**CITY OF MERIDIAN
FINDINGS OF FACT, CONCLUSIONS OF LAW
AND DECISION & ORDER**

In the Matter of the Request for Annexation of 31.96 Acres of Land with an R-4 Zoning District; and a Preliminary Plat Consisting of 75 Buildable Lots, 11 Common Lots and 2 Other Lots on 30.6 Acres of Land in the R-4 Zoning District, by Todd Tucker, HHS Construction, LLC.

Case No(s). H-2019-0123

SUBJECT: Sky Mesa Highlands
 H-2019-0123

PP-03

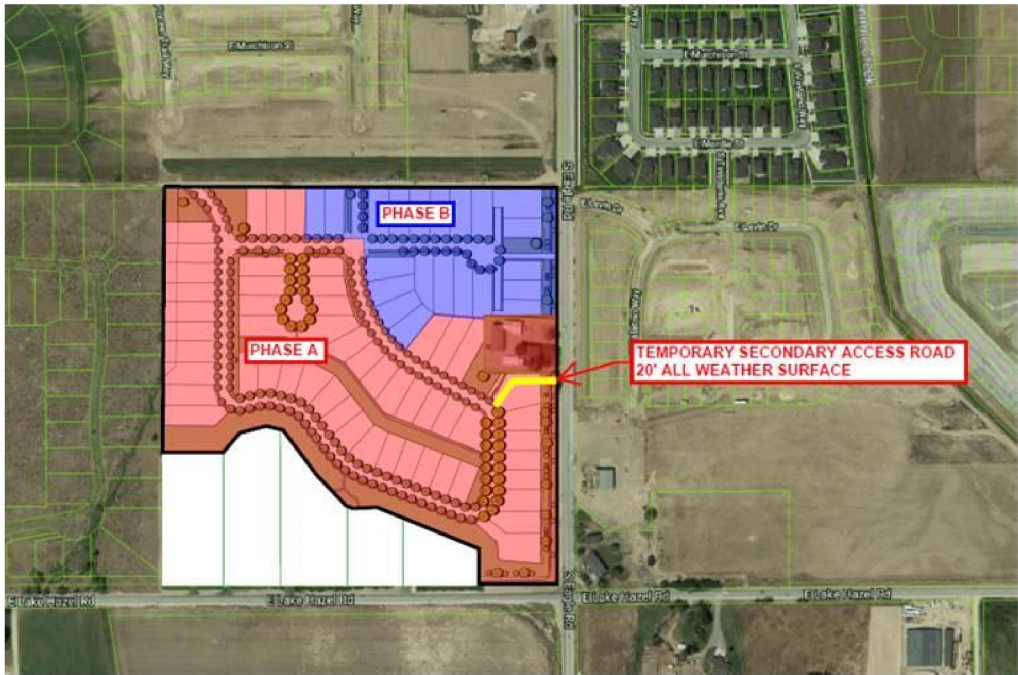
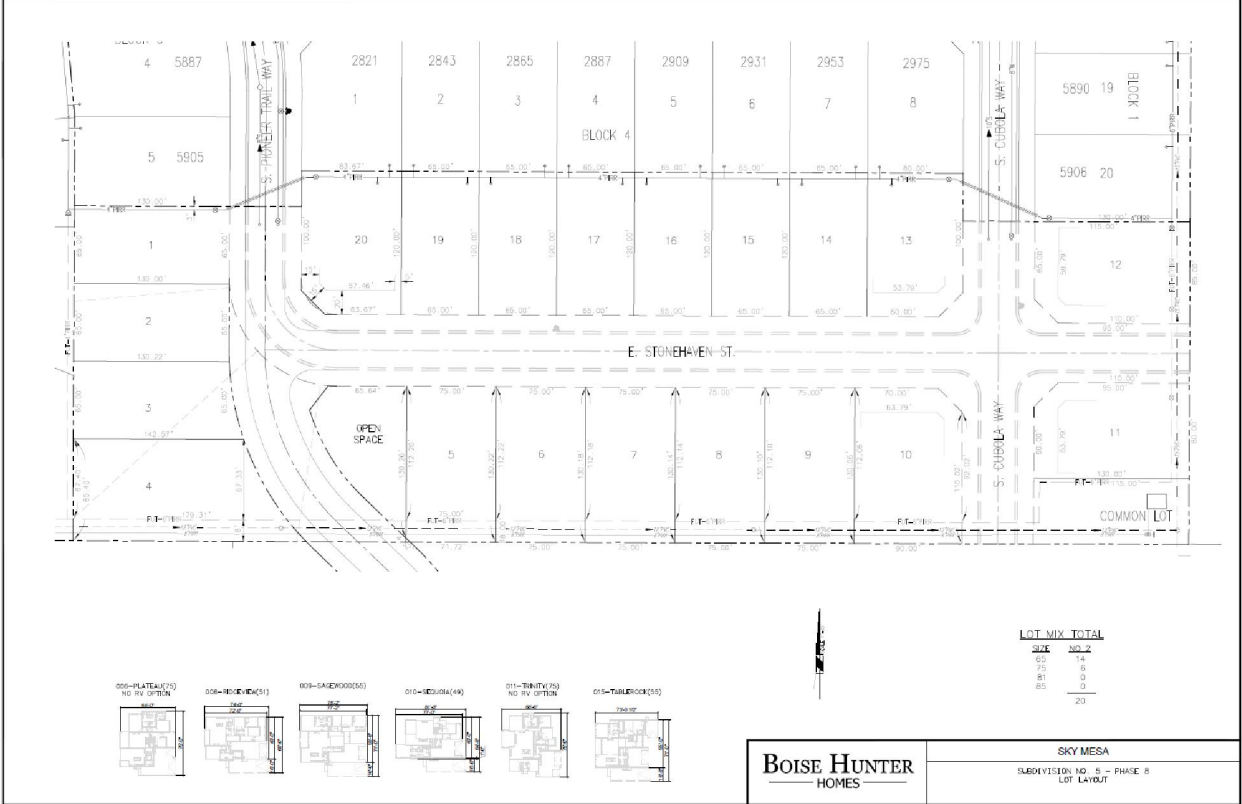
2. The preliminary plat included in Section VII.B, dated 10/22/2019, shall be revised **prior to the City Council hearing** as follows:
- a. ~~Remove the existing driveway access via S. Eagle Rd. on Lot 2928, Block 1 where the existing home is to remain in accord with UDC 11-3A-3A.3, unless otherwise waived by City Council. If access via Eagle Rd. isn't approved, access should be provided via a common driveway as depicted on the conceptual redevelopment plan in Section VII.B. The City Council approved the Applicant's request for a waiver to UDC 11-3A-3A.3 for the existing driveway accesses to remain until redevelopment occurs.~~

- d. ~~Lot 29, Block 1 is required to have street frontage on a public street (30' flag or 60') or on a common driveway, which doesn't require frontage per UDC 11-2A-3B and Table 11-2A-5. The revised plat depicts access via a common driveway.~~

- g. **~~The irrigation easements depicted along the west and north property boundaries shall be included in common lots outside of a fenced area, unless otherwise modified~~**

~~by City Council per UDC 11-3A-6E. The revised plat depicts the irrigation easements within common lots; no waiver was requested or approved by City Council.~~

Conceptual redevelopment plan for Lot 2928, Block 1

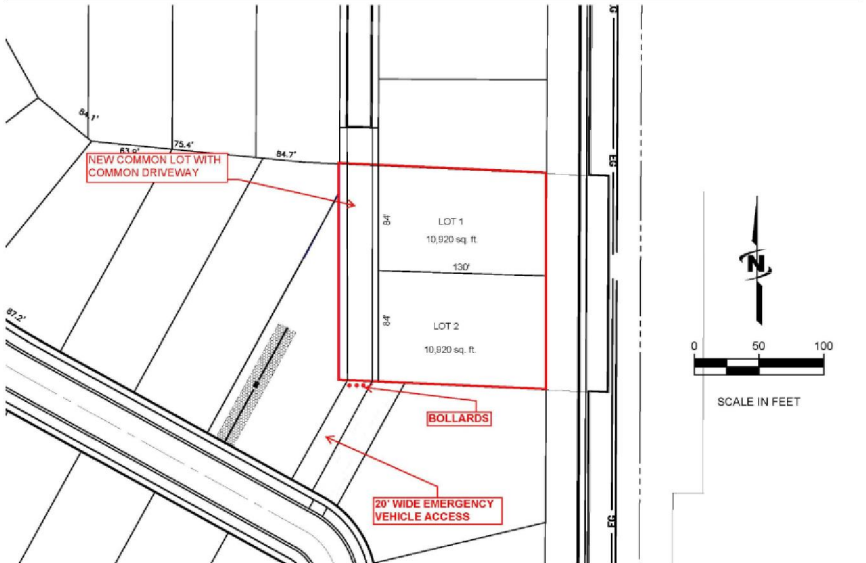
- f. The City Council approved the Applicant's request for a waiver to UDC 11-3A-3A.3 to allow the existing accesses via Eagle Rd. to remain for Lot 28, Block 1 until the property redevelops in the future. Upon redevelopment, access shall be taken internally from within the subdivision via a common driveway and emergency access shall be provided as shown on the conceptual redevelopment plan included in Section VII.B.

LANDSCAPE PLAN OVERVIEW

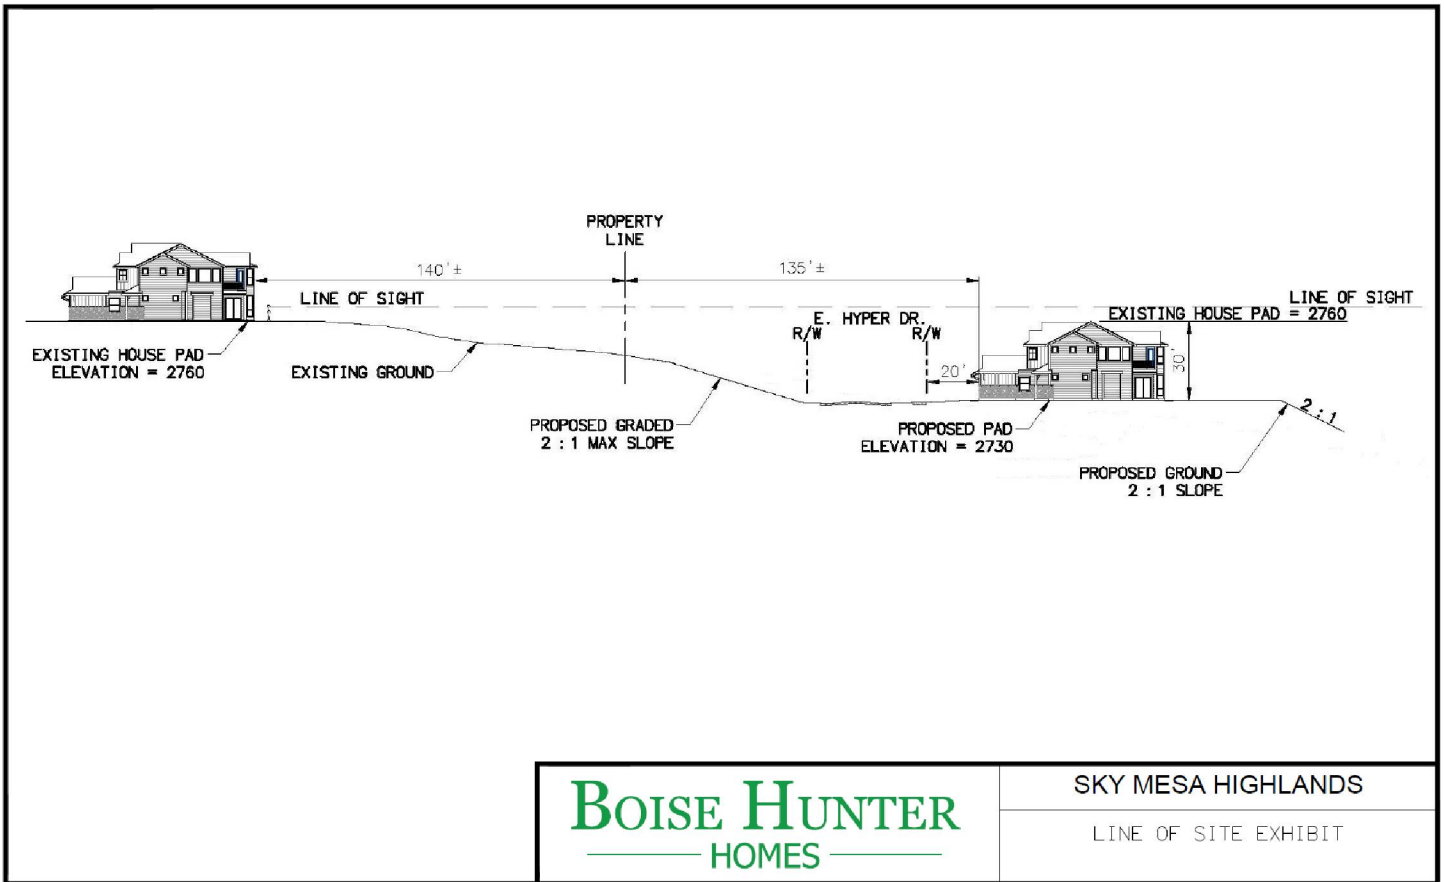
3. The landscape plan included in Section VII.C, dated 10/22/2019, shall be revised **prior to the City Council hearing** as follows:
 - a. ~~Remove the existing driveway access via S. Eagle Rd. on Lot 2928, Block 1 where the existing home is to remain in accord with UDC 11-3A-3A.3, unless otherwise waived by City Council. The City Council approved the Applicant's request for a waiver to UDC 11-3A-3A.3 for the existing driveway accesses to remain until redevelopment occurs.~~

- f. Correct "Block 1 Lot 50" in the Landscape Requirements table to read "Block 1 Lot 49".
 - g. Depict landscaping along the pathways in Lot 14, Block 3 and Lot 10, Block 1 in accord with the standards listed in UDC 11-3B-12C; include calculations in the Landscape Requirements table for the linear feet of pathways proposed and the number of trees required and proposed that demonstrate compliance.

- i. If topography allows, extend the pathway on Lot 14, Block 3 out to the sidewalk along Pioneer Trail Way.
 - j. **The irrigation easements depicted along the west and north property boundaries shall be included in common lots outside of a fenced area, unless otherwise modified by City Council per UDC 11-3A-6E. The revised plat depicts the irrigation easements within common lots; no waiver was requested or approved by City Council.**

- l. Trees planted within the common lot on Lot 10, Block 1 shall be planted at the base of the slope and depicted accordingly on the plan.
4. All common driveways shall comply with the standards listed in UDC 11-6C-3D.
